Aberfeldy Village Masterplan Interim Review Report Response

Aberfeldy Village Masterplan ES Interim Review Report Response

This ES Interim Review Report Response document constitutes the response of the Applicant to the ES Interim Review Report (IRR) received from the London Borough of Tower Hamlets (LBTH) on the 20th January 2022 relating to the EIA for the redevelopment of the Aberfeldy Village Masterplan submitted in supported of the hybrid planning application in October 2021 (Ref. PA/21/02377/A1). The IRR was prepared by Temple on behalf of the LBTH. This document is structured as follows in line with the structure set out within the IRR:

Board Comparison

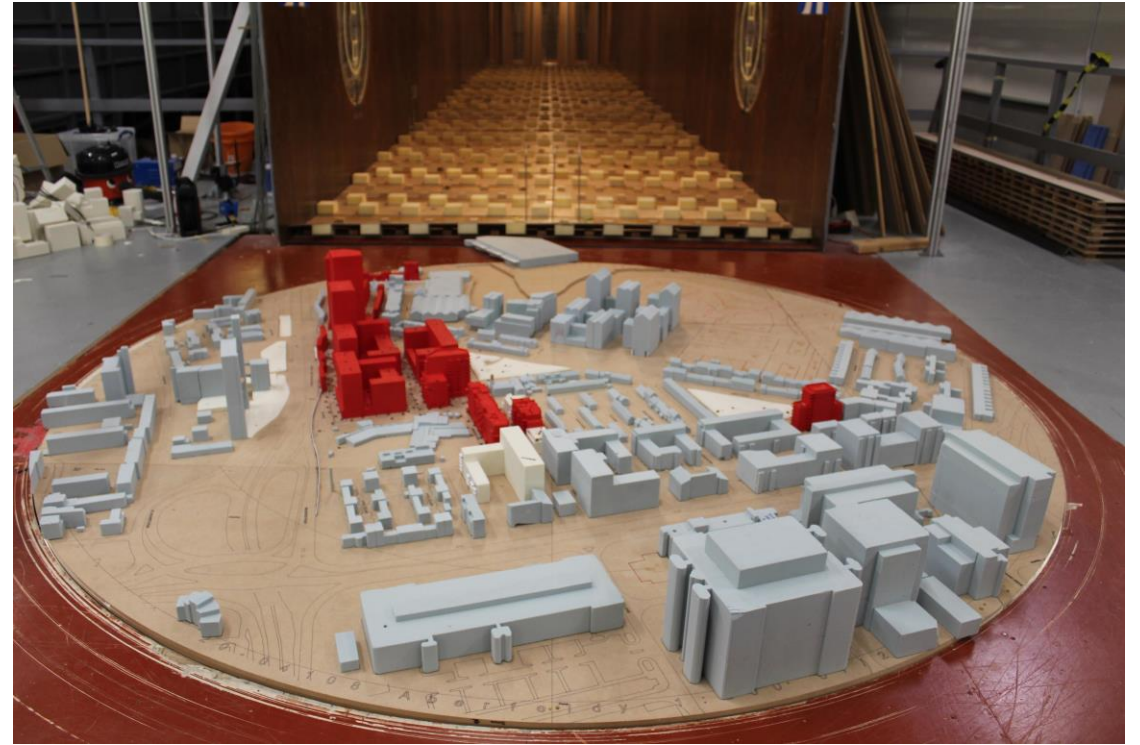
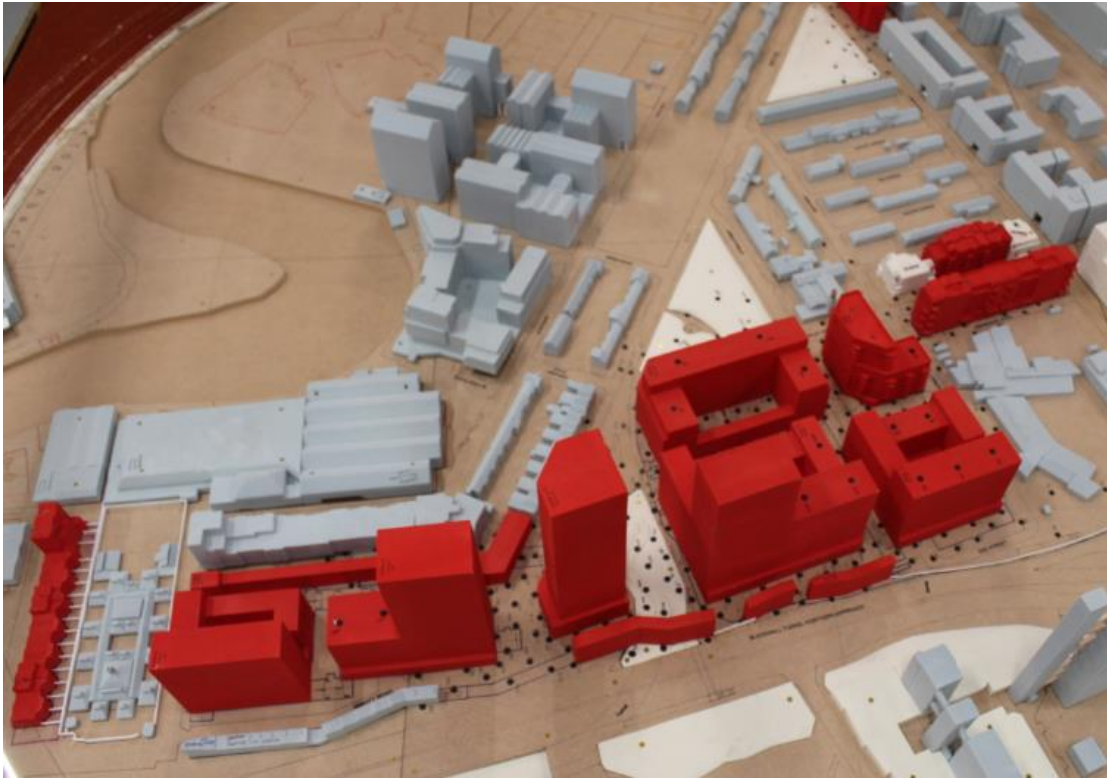
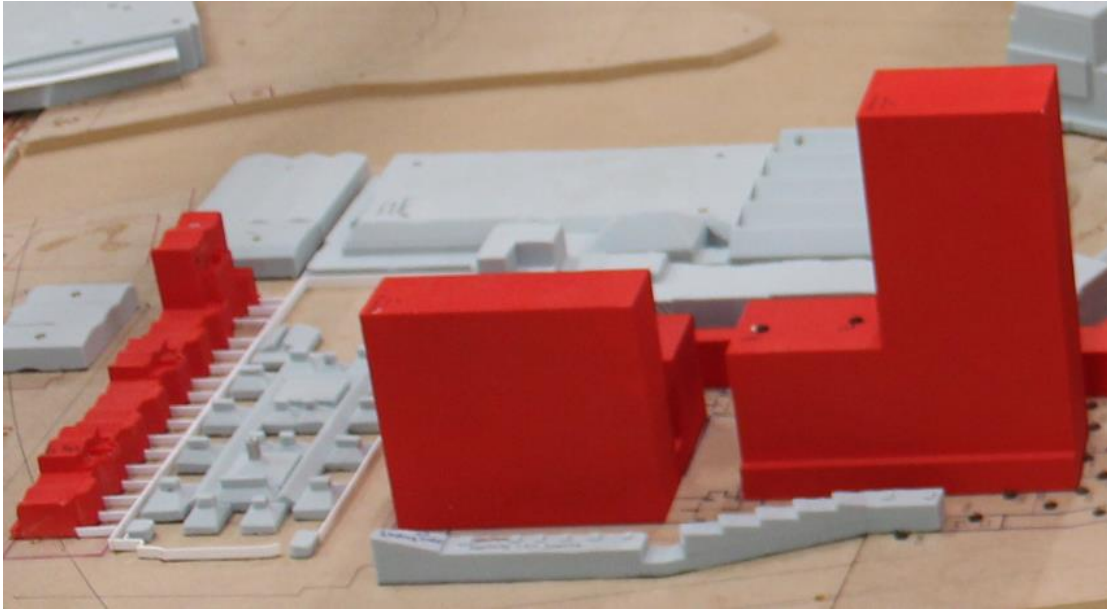
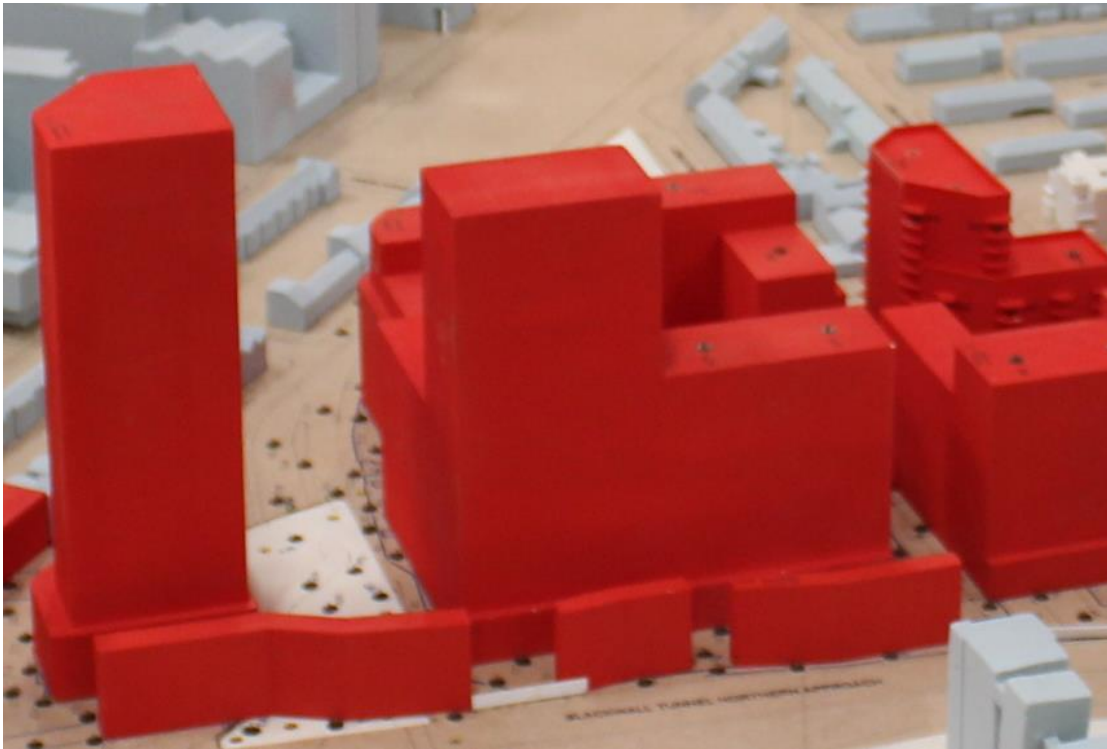
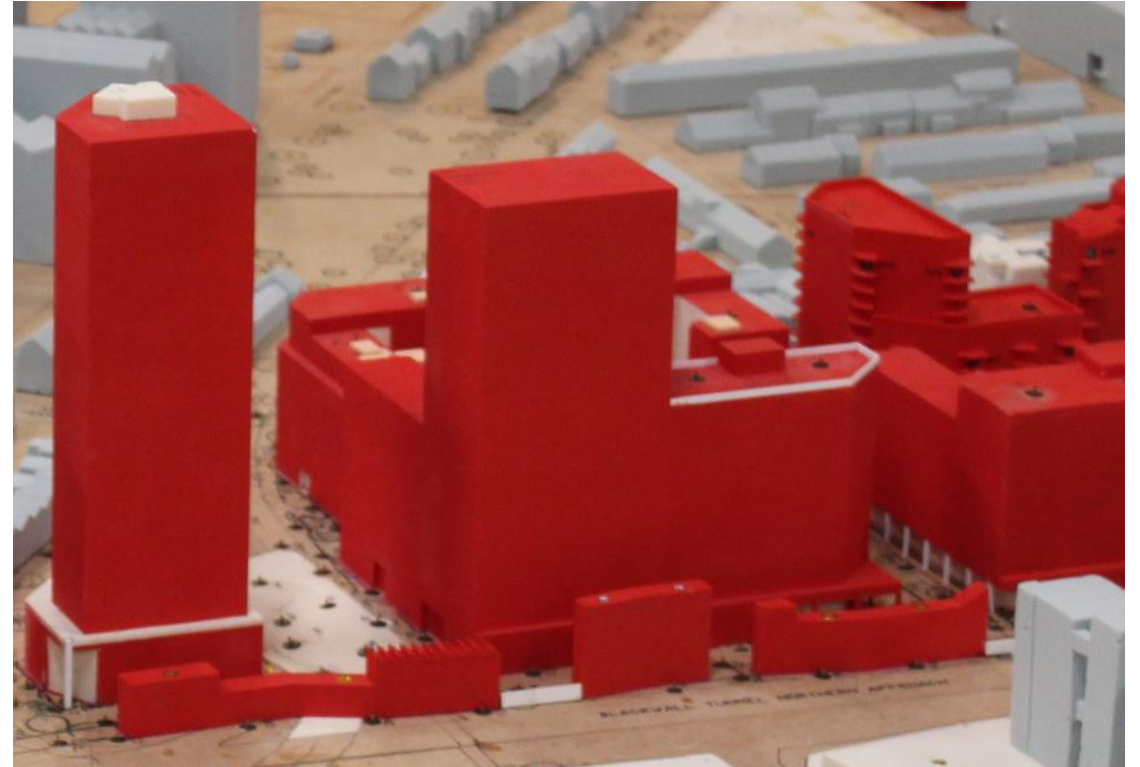
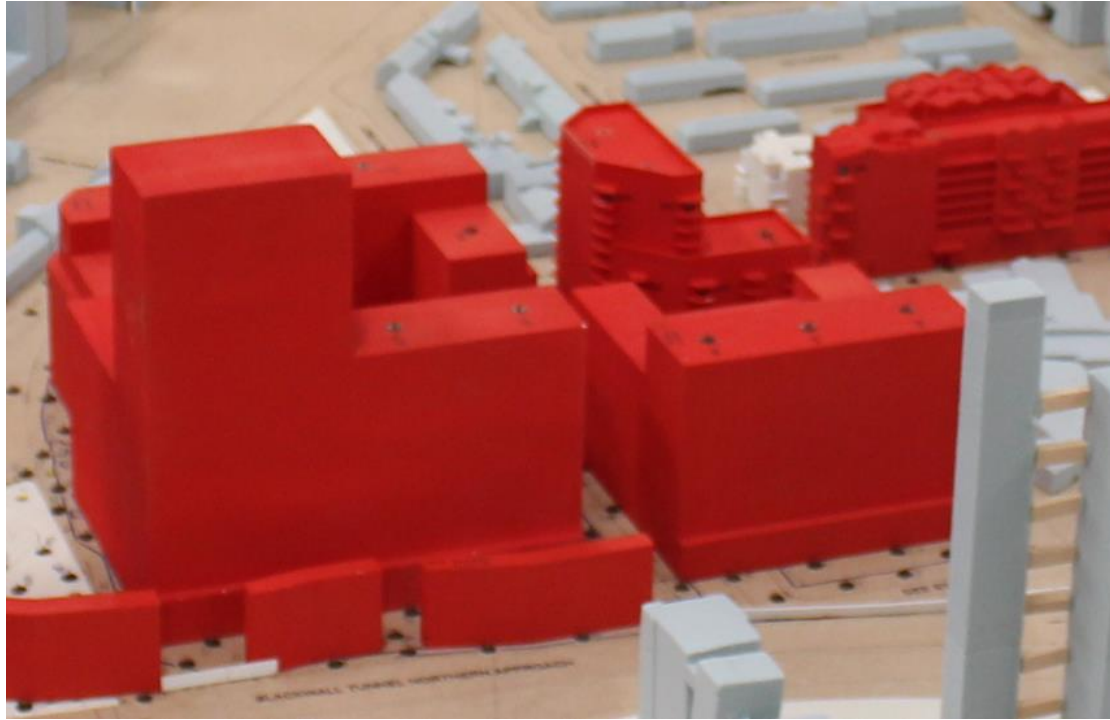
Wind Microclimate IRR Ref 47	Clarification	No close-up photos of the proposed development are provided making it difficult to appreciate the difference between maximum parameters and the illustrative scheme. It is requested that these be provided or images of a 3D model be provided as an alternative.	Images showing the comparison between the Maximum Parameters model and the Illustrative Scheme model are provided in Appendix B, Annex C of this document.
Wind Microclimate IRR Ref 48	Clarification	No photos of mitigation measures are provided making it difficult to verify that the modelling adopted is acceptable. It is requested that comprehensive photographs be provided.	The figures showing the soft landscaping proposals and wind mitigation measures provided in Appendix B (Annex B) of this document include photos of the proposed mitigation measures for clarity.
Wind Microclimate IRR Ref 49	Clarification	Paragraph 13.52 notes that "localised occurrences of walking conditions may be acceptable in areas with limited footfall, or service areas, as long as the strong wind criteria (see section 'Strong Winds') is not exceeded." The CoL guidelines do not permit the presence of walking conditions, thus it is requested that this statement be clarified.	This assessment is based on the Lawson Comfort Criteria as outlined in the scoping report and the EIA Scoping Opinion Response provided in ES Volume 3, Appendix: Methodology, Annex 3. See above response to point 46 in relation to the use of the CoL guidelines. Walking use conditions would occur at probe locations 177 and 274 during the windiest season. These areas fall within the illustrative proposals and as such qualitative mitigation measures were recommended in the form of additional trees 6m tall localised at two sides of the north-western corner of Plots C1 and B3 as discussed in Table 13.7 of ES Volume 1, Chapter 13: Wind Microclimate. The specific mitigation measures required for the outline/illustrative proposals that will be implemented will be determined and tested at the reserve matters application stage and secured by an appropriately worded planning conditions as suggested in Paragraph 13.219 of ES Volume 1, Chapter 13: Wind Microclimate.

Pedestrian Wind Usage Conditions - Ground Floor
 Configuration 2: Proposed Development with Existing Surrounding Buildings

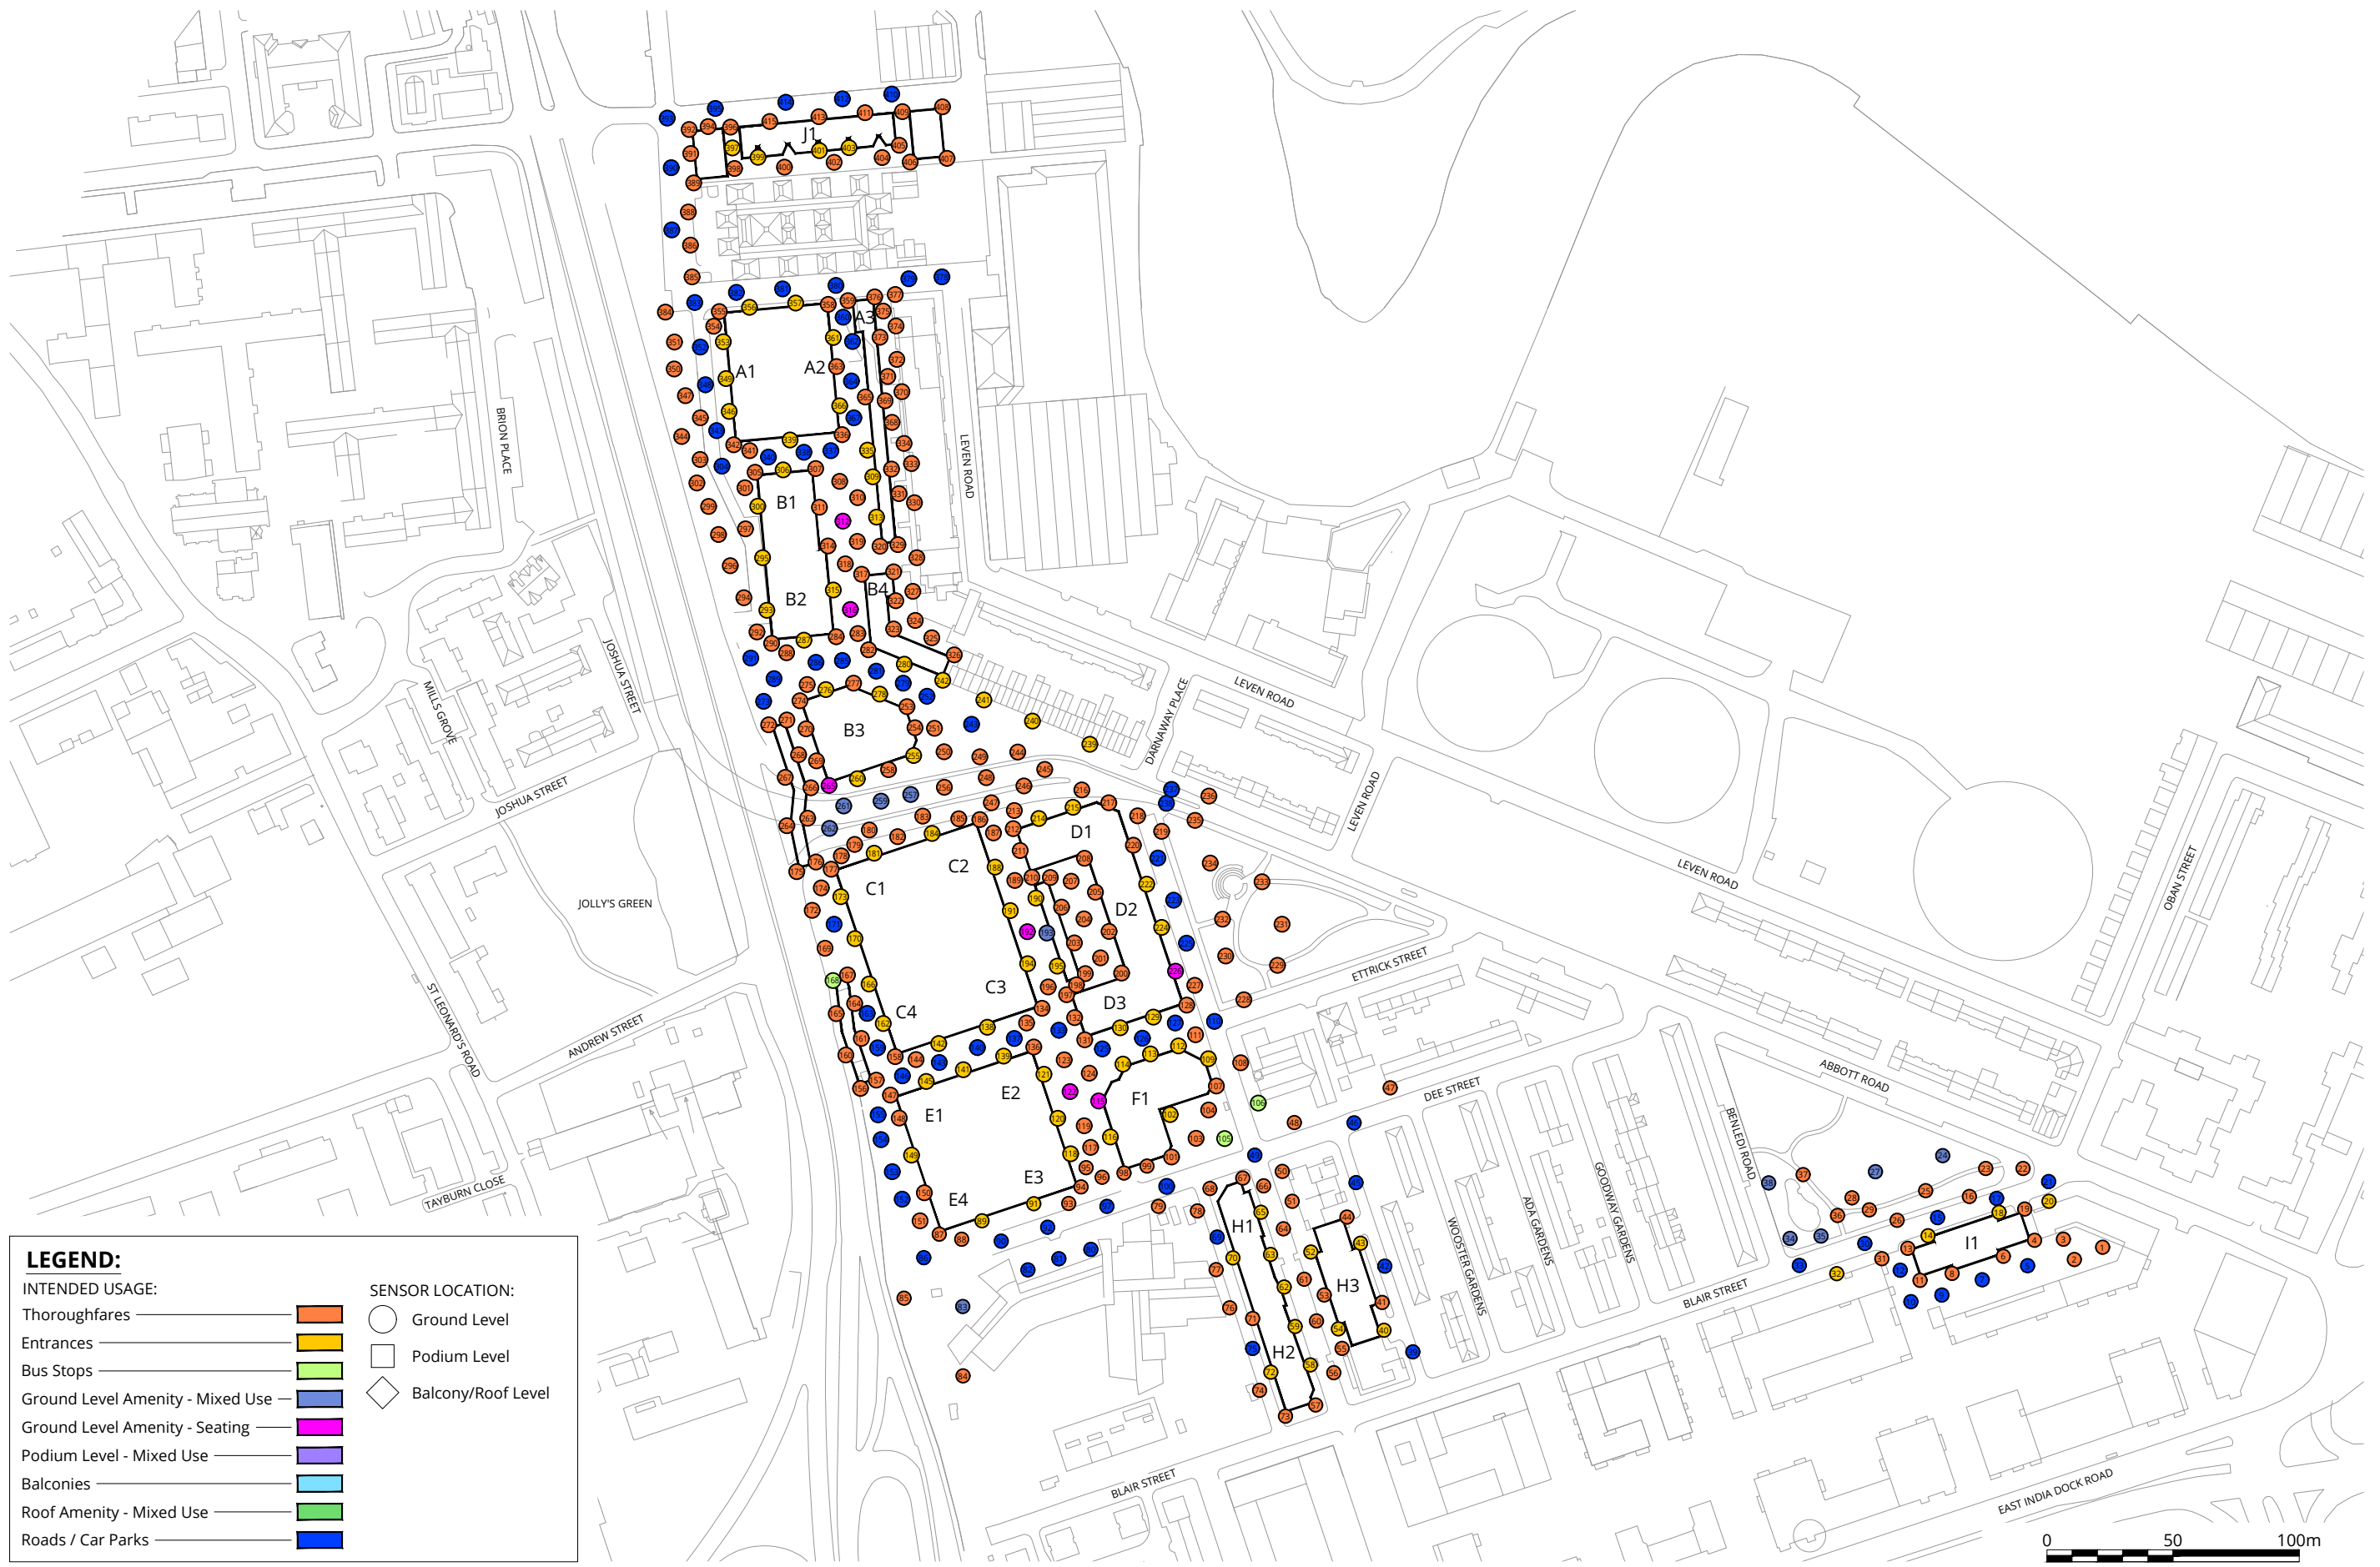
Wind Microclimate IRR Ref 43	Clarification	A plan showing the intended uses of the Application Site, requested by LBTH, is not presented. It is requested that this be provided.	Figures showing the intended usage across the Proposed Site Development are provided in Appendix B, Annex D of this document.
Wind Microclimate IRR Ref 44	Clarification	A plan showing what conditions are being targeted, requested by LBTH, is not presented. It is requested that this be provided.	Figures showing the target conditions across the Proposed Development are provided in Appendix B, Annex D of this document.

Figure 1: Extract from ZTV map showing the location the former Royal Oak PH

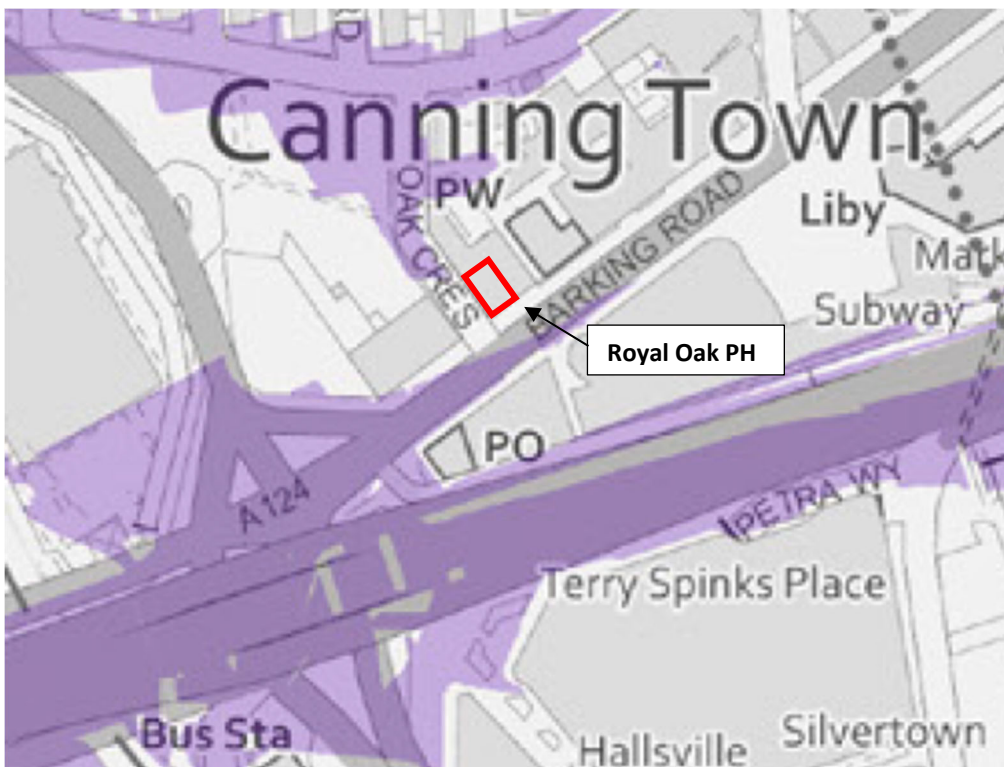
As the ZTV map view cones illustrate, the long views of the Proposed Development travel in the direction of west-to-east and not north-to-south therefore none of the proposed new buildings, which are almost 1km away, would appear in the setting of the receptor (figs. 1 & 2):

The receptor does not fall within the ZTV and therefore there is no intervisibility between the former Royal Oak Public House and the Site.
